SINCLAIR hille architects

Addendum #3

Project Name:	Concordia STEM Seward, NE
Project No.:	16022-05
Date Issued:	May 11, 2018
Bid Date:	Thursday, May 17, 2018

1 Main Level Lighting Plan – Area B.3
1/4" = 1'-0"

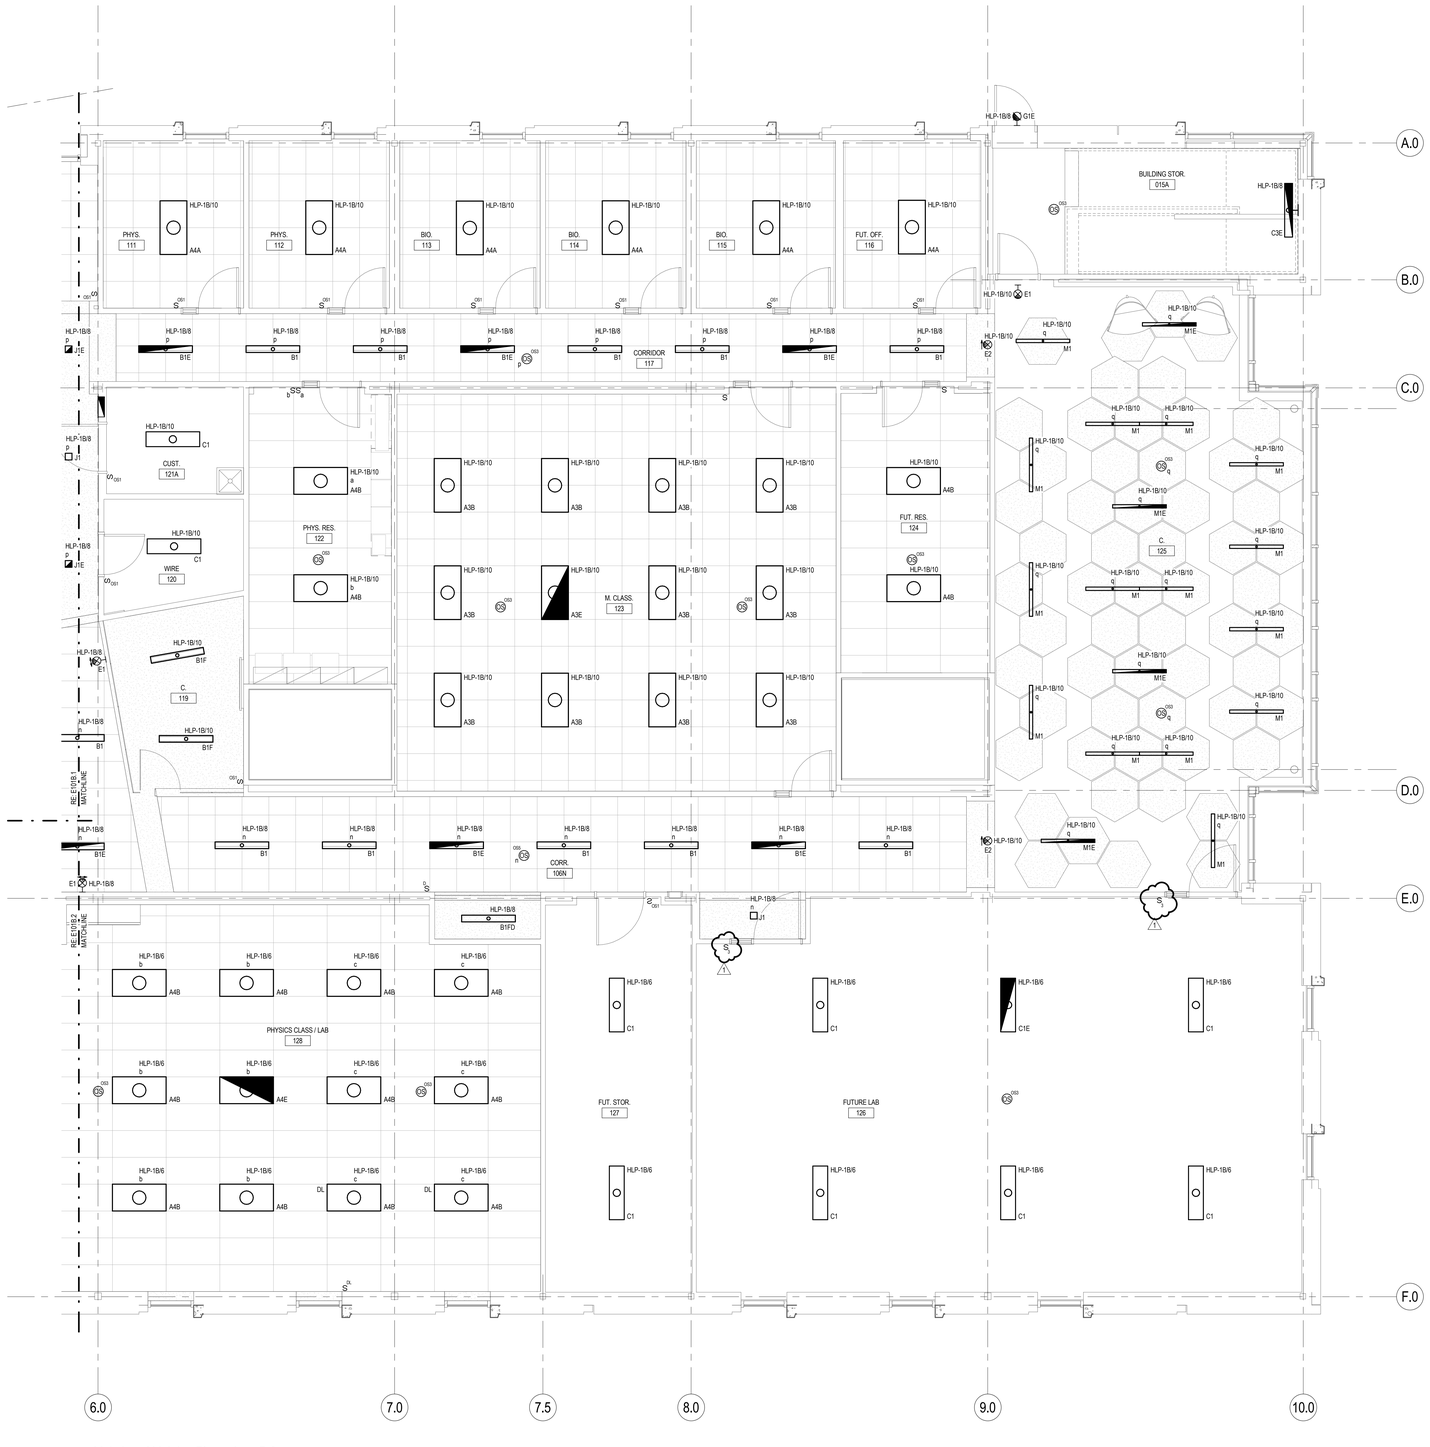
ADD 3-24. Drawing E101B.3 Added three way switching to Future Lab room 126.

1 Lower Level Power Plan – Area A.1
1/4" = 1'-0"

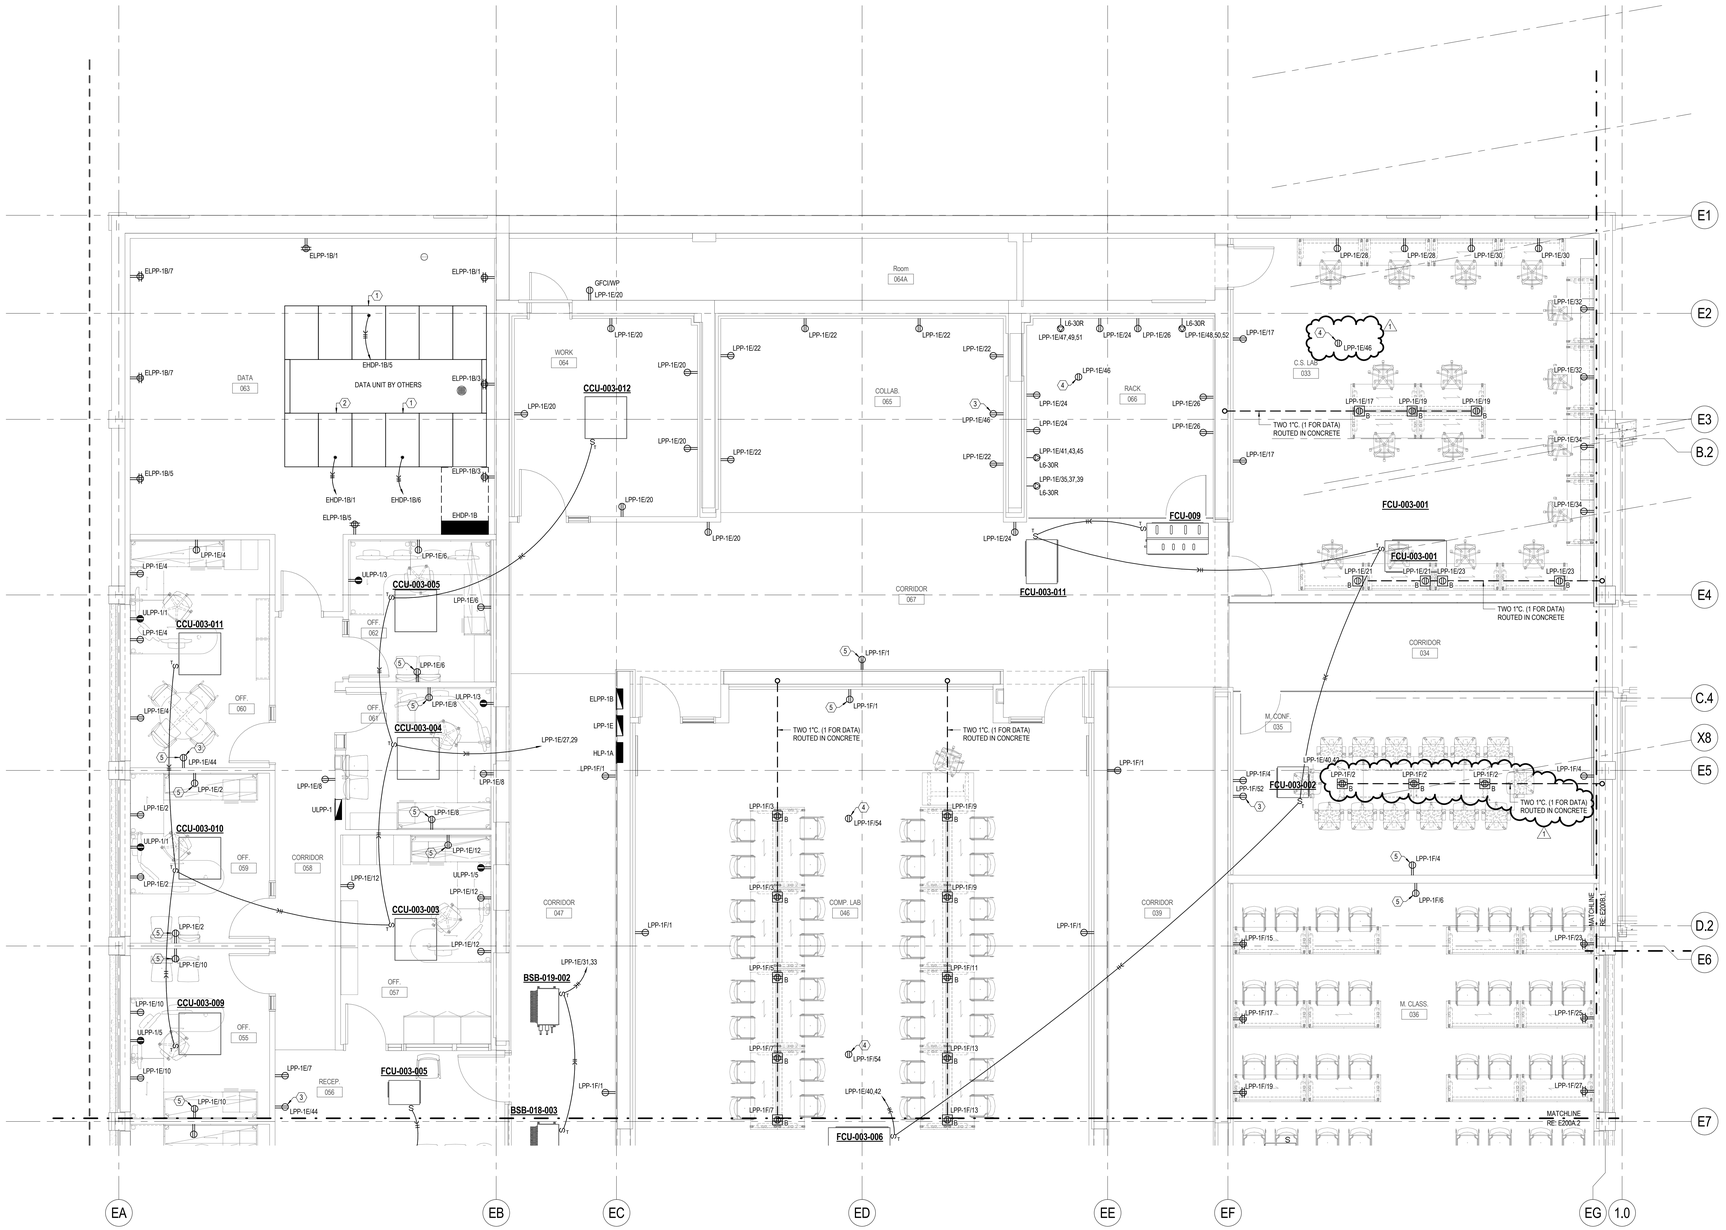
ADD 3-27. Drawing E200A.1. Floor boxes in M Conf 035 shall be Type B instead of Type A. Route 2-1” conduits in concrete instead of 1-1” conduit.

ADD 3-28. Drawing E200A.1. Provide a duplex receptacle (LPP-1E/46) for ceiling mounted projector in C.S. Lab 033. Projector is located in southwest corner of room near door into Room 064A.

1 Lower Level Power Plan – Area B.1
1/4" = 1'-0"

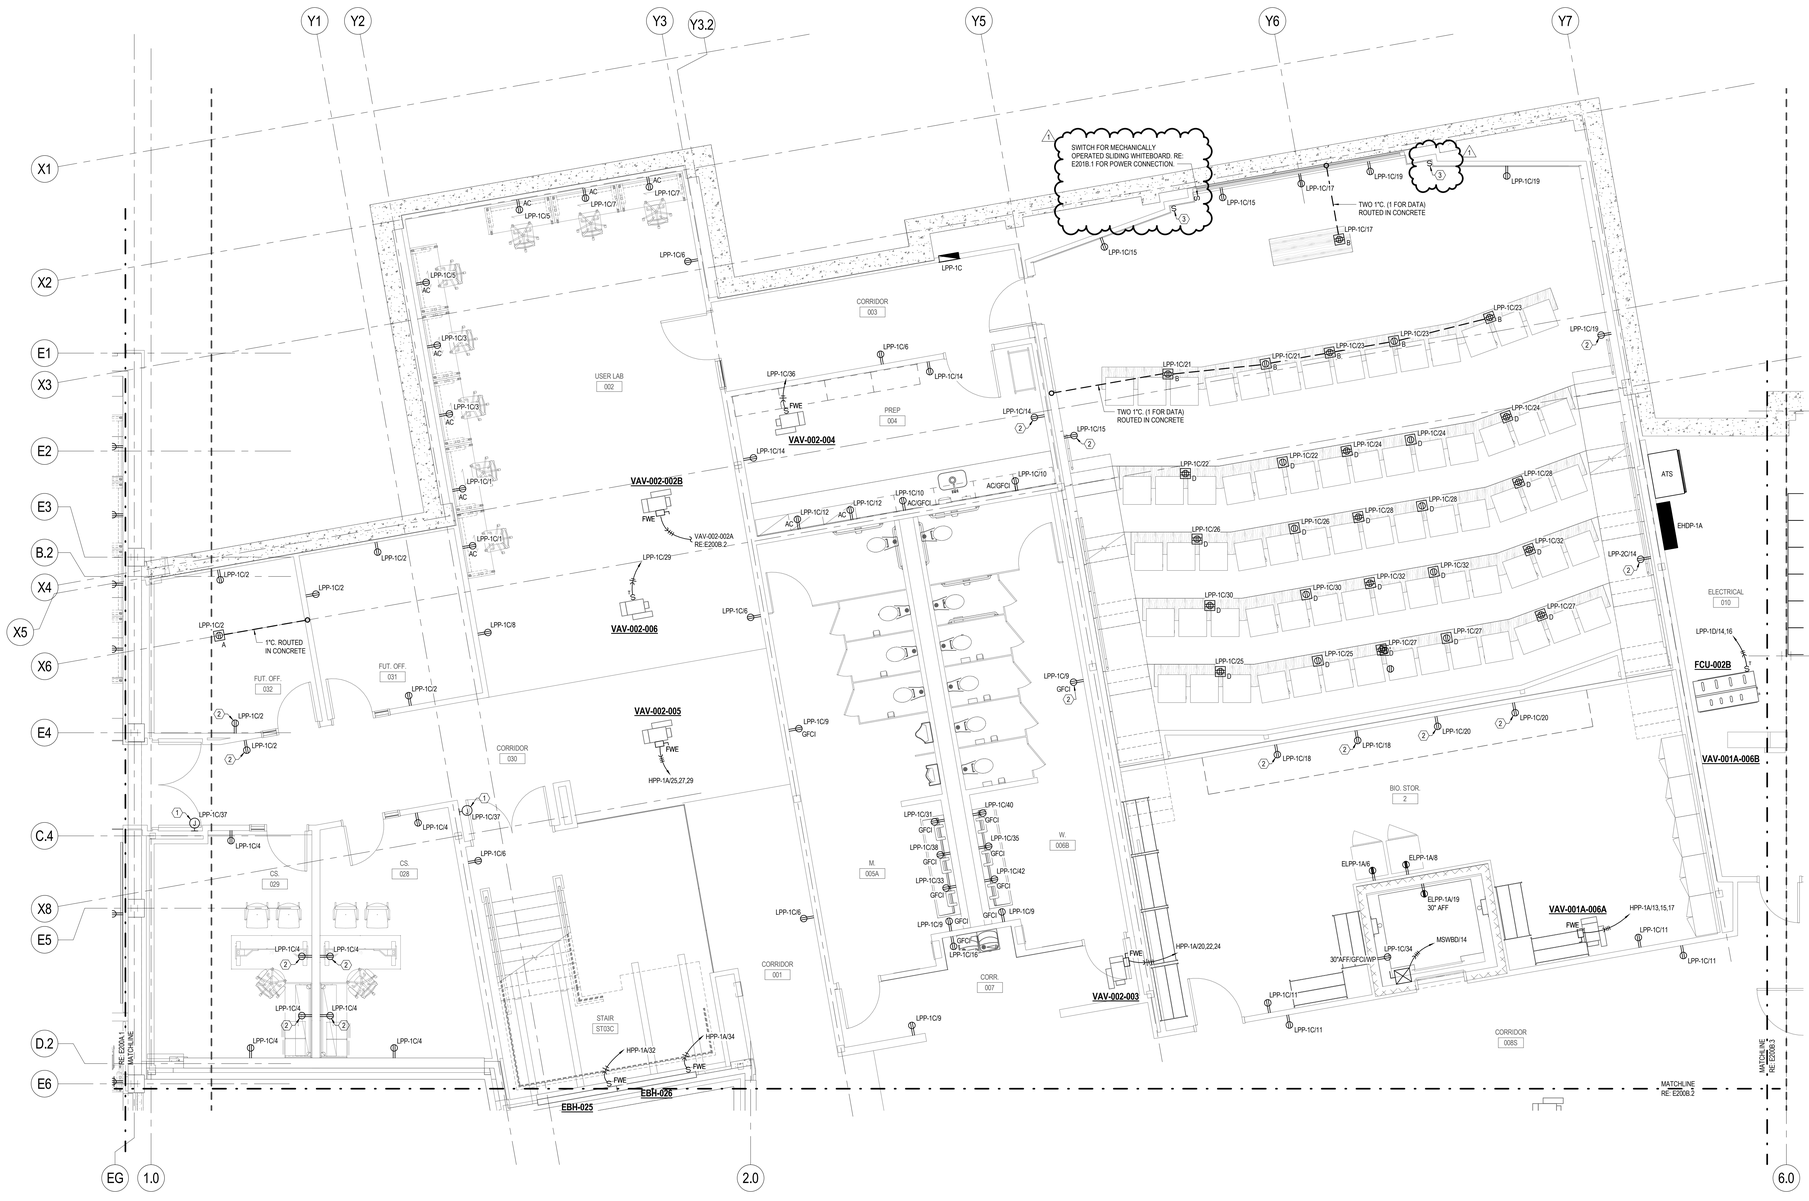
ADD 3-29. Drawing E200B.1. Main Level furniture was turned off. Motorized shade switches were moved to the proper level. Switch was added for Mechanically operated sliding whiteboard

1 Lower Level Power Plan – Area B.2
1/4" = 1'-0"

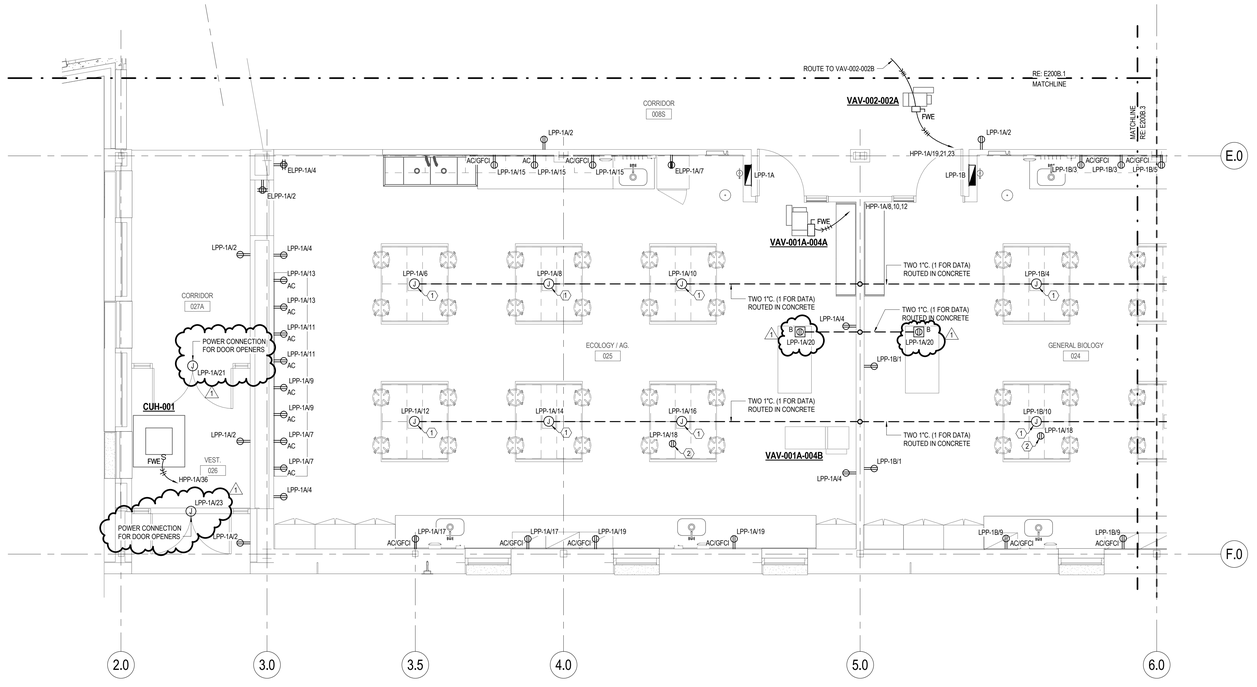
ADD 3-30. Drawing E200B.2. Floor box type “B: in General biology 024 shall be on LPP-1A/20.

ADD 3-31. Drawing E200B.2. Floor box type "B" in Ecology/Ag 025 shall be on LPP-1A/20. Power was added for powered door openers in Vestibule 026.

1 Lower Level Power Plan – Area B.3
1/4" = 1'-0"

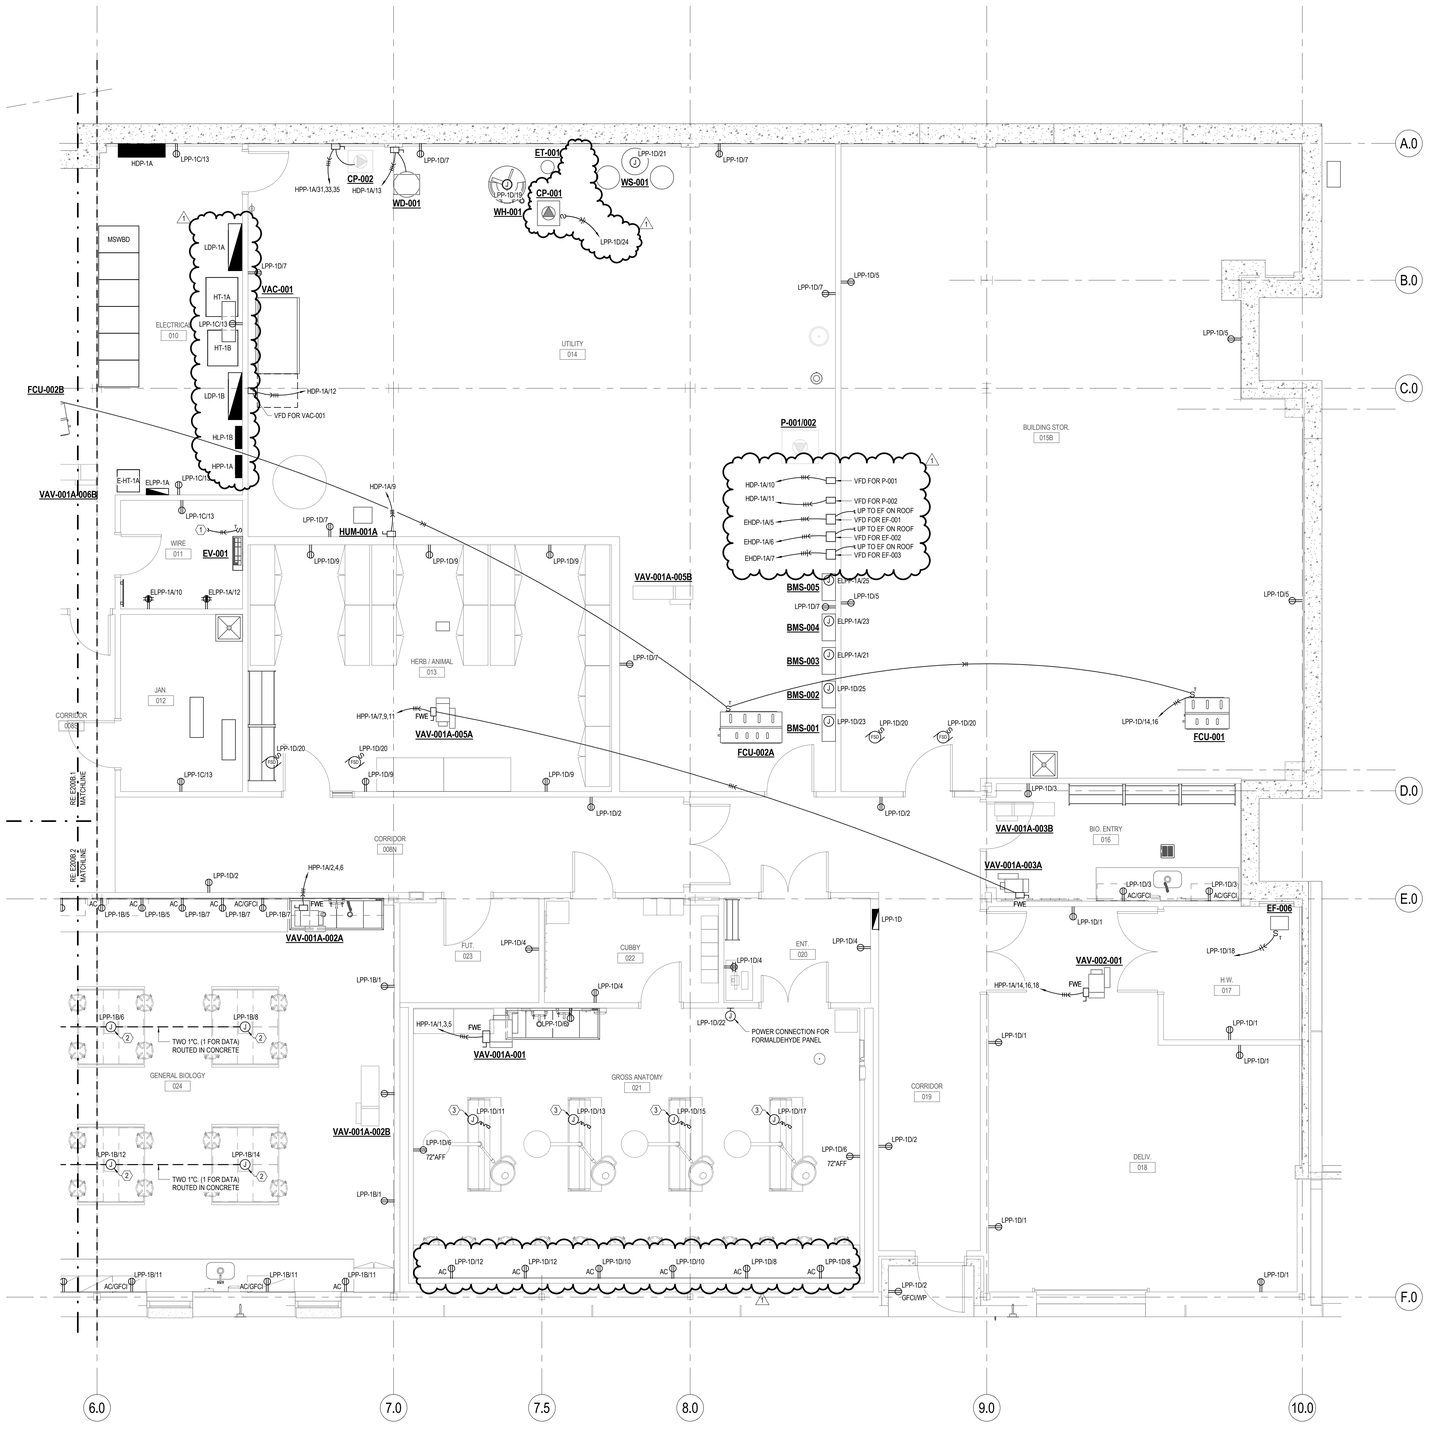
ADD 3-32. Drawing E200B.3, E203B.3, and E500 for Lab Exhaust Fans EF-001, EF-002, EF003. Provide a NEMA 3R, 100 amp, 3 pole non-fusible disconnect switch with electrical interlock on roof by exhaust fan. Provide a variable frequency drive (with dV/dT filter) and locate drive in Utility Room 014 by VFD's for Pumps P001 & P002. Electrical interlock will disable VFD when the disconnect switch is turned off. Provide VFD cable and interlock wiring from VFD to disconnect switch.

ADD 3-33. Drawing 200B.3. Adjusted wall mounted receptacles in Gross Anatomy 021. Moved electrical equipment mounted on north wall 18" to the east. Changed CP-001 from 480v. to 120v. circuit.
